Re: Intermountain Power Project
B&W Ref: RB-614/615
Subject: Burner Design Issues

Subject: Response to B&W's Modified Burner Design

INTERMOUNTAIN POWER PROJECT MODIFIED BACK PLATE

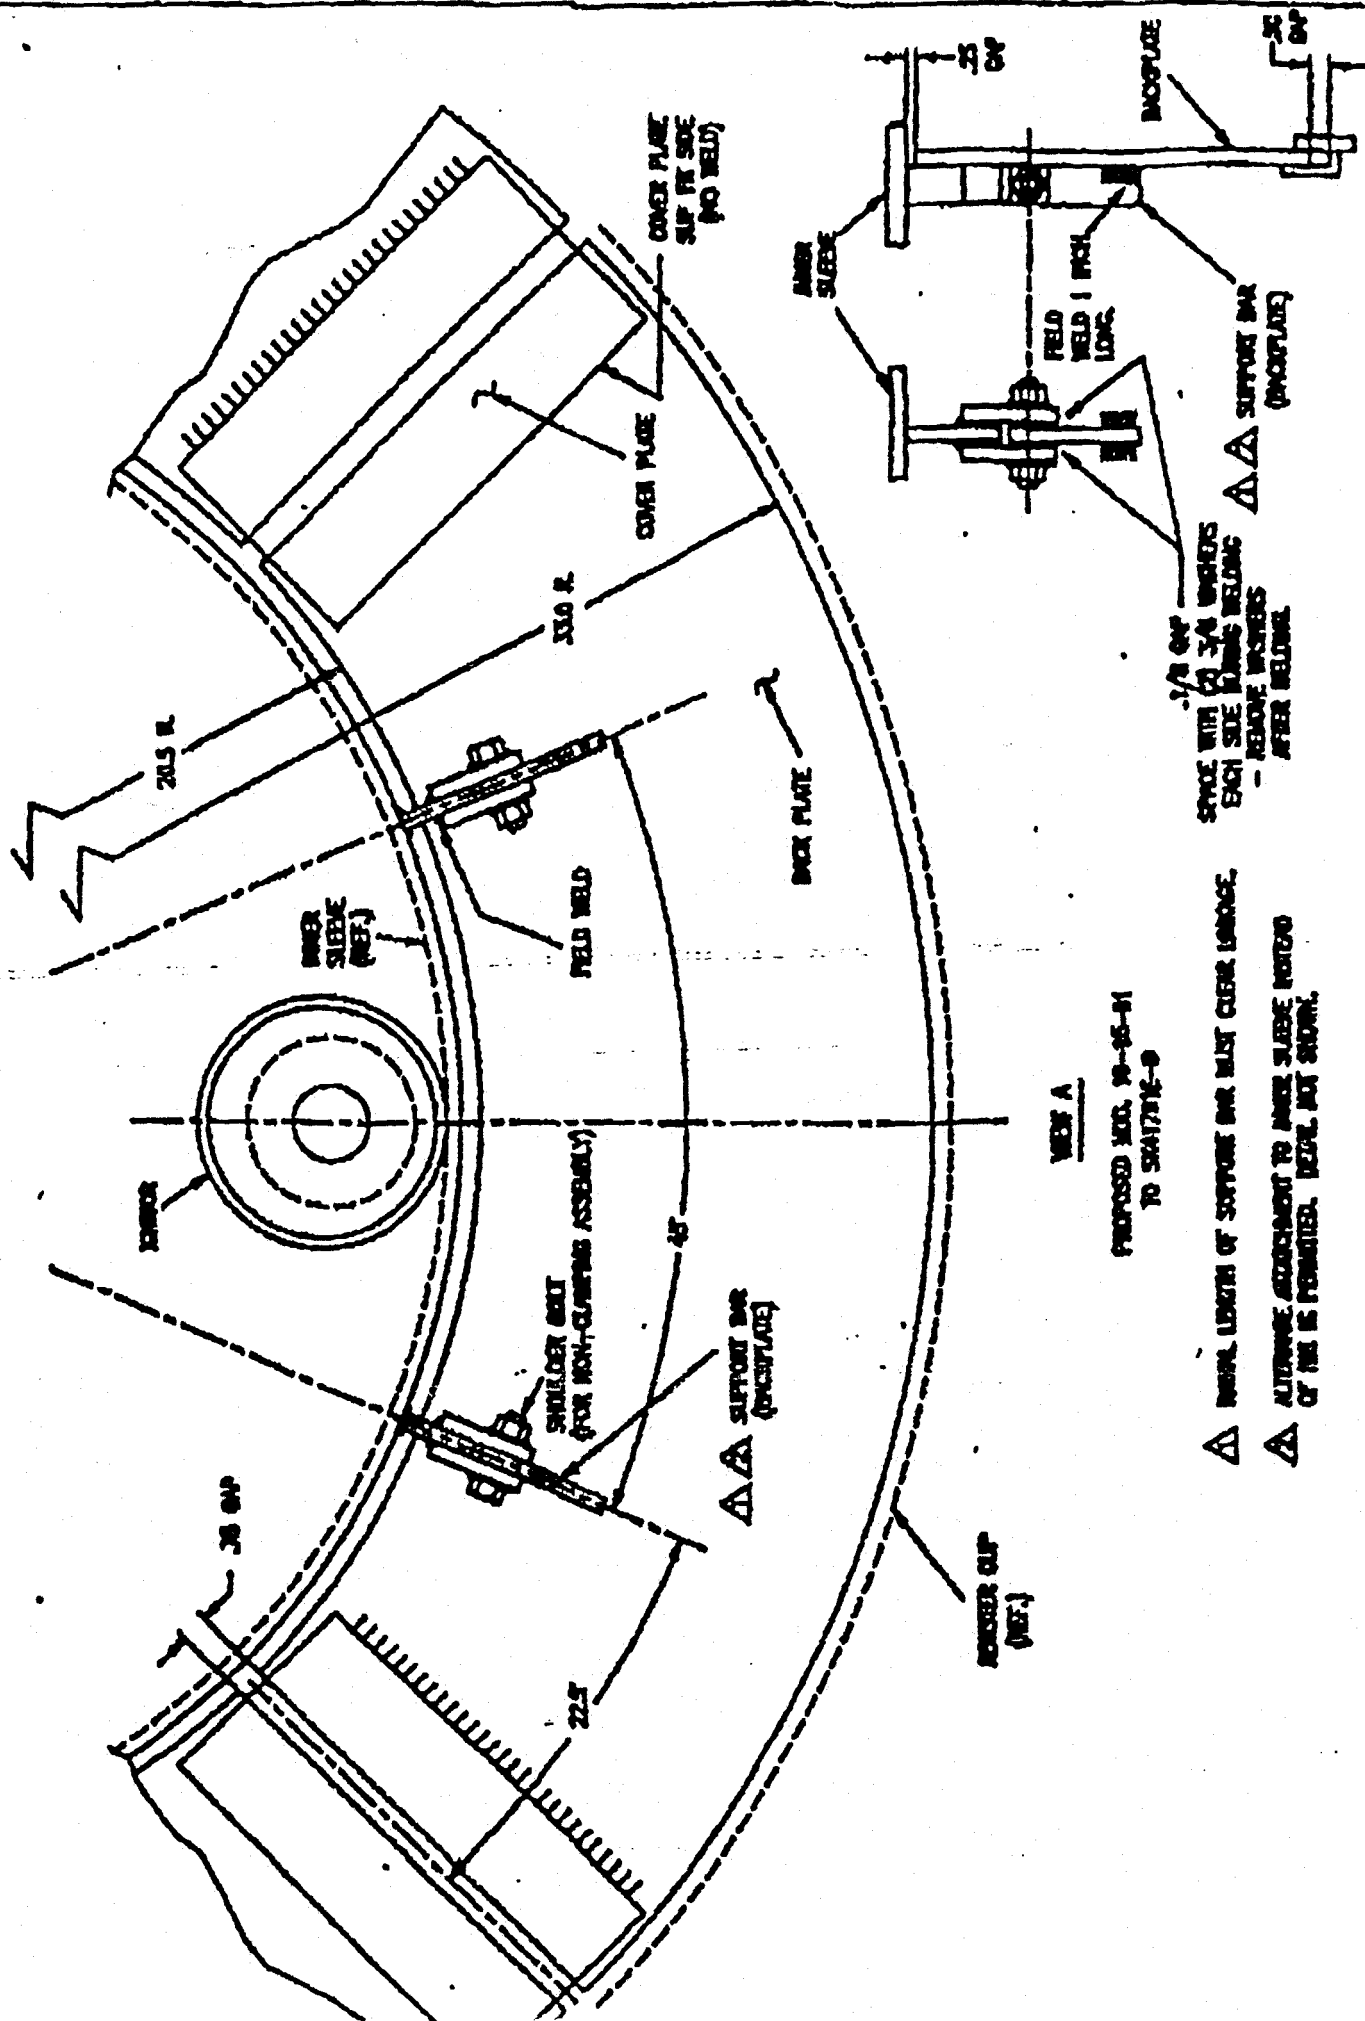
- a. Circumferential Clearance between Segments- Total circumferential clearance should equal 3 inches. With six segments as B&W has recommended, the radial clearance between segments should be 0.5 inches. If this gap is triangular shaped, minimum clearance should remain 0.5 inches.
- b. Radial Clearance between Segments- Radial clearance on each of the backplate segments should be 0.25 at the inner annulus (ID) and 0.5 on the outer annulus (OD) for thermal growth allowances.
- c. Backplate Axial Support- Axial support needs to be provided to center each of the backplate segments to allow for the radial and axial clearances previously stated. RJM has recommended a shoulder bolt attachment arrangement (drawing enclosed) which we would like to see utilized unless a better attachment can be proposed.

- d. Outer Annulus Radial Support- Additional radial supports should be provided to the outer annulus of the backplate assembly, beyond the support provided by the additional support rails proposed by B&W. We are recommending additional radial supports attached to the outer ring and anchored to the axial braces on the nozzles support sleeve (a minimum of four; one per each of the six backplate segments minus the two rail supports).
- e. Segment Cover Plate- A slip fit cover plate is recommended to be attached to each segment joint to minimize air leakage.

- e. With B&W's interconnected backplate segment design, the required gap between each segment is minimal. However, since we are increasing the gap to 3/8", see above, B&W will add lap plates to cover the gap between segments. RJM agreed with this approach and suggested that B&W check to see how much the gap changes when the assembly is hanging freely after the shipping restraints are removed. B&W will do so.

Figure 39 Segmented Back Plate

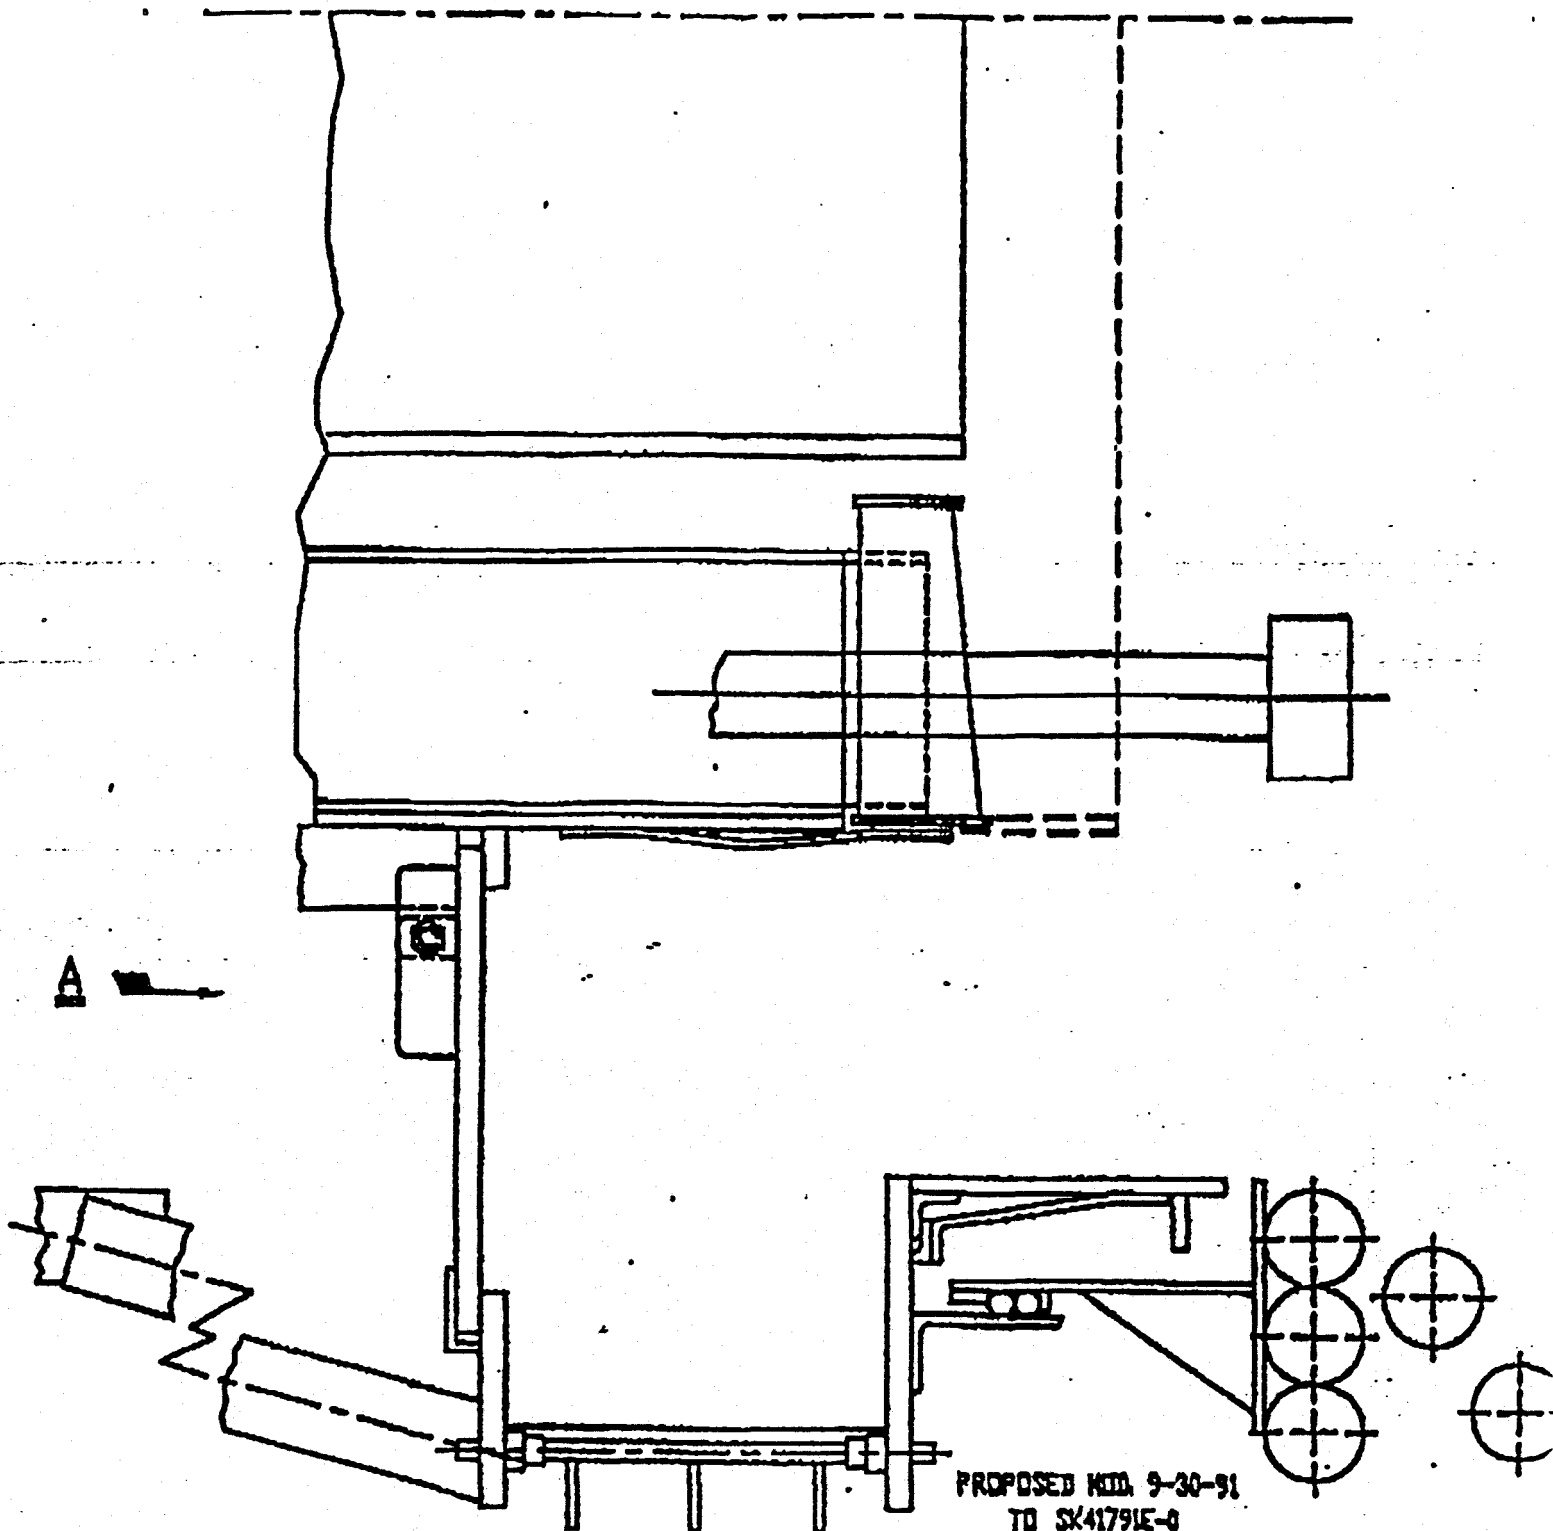
- △ MIN. LENGTH OF SUPPORT BAR MUST CLEAR UNDOG.
- △ ALTERNATE ATTACHMENT TO INNER SLIDE INSTEAD OF THIS IS PERMITTED. DETAIL NOT SHOWN.
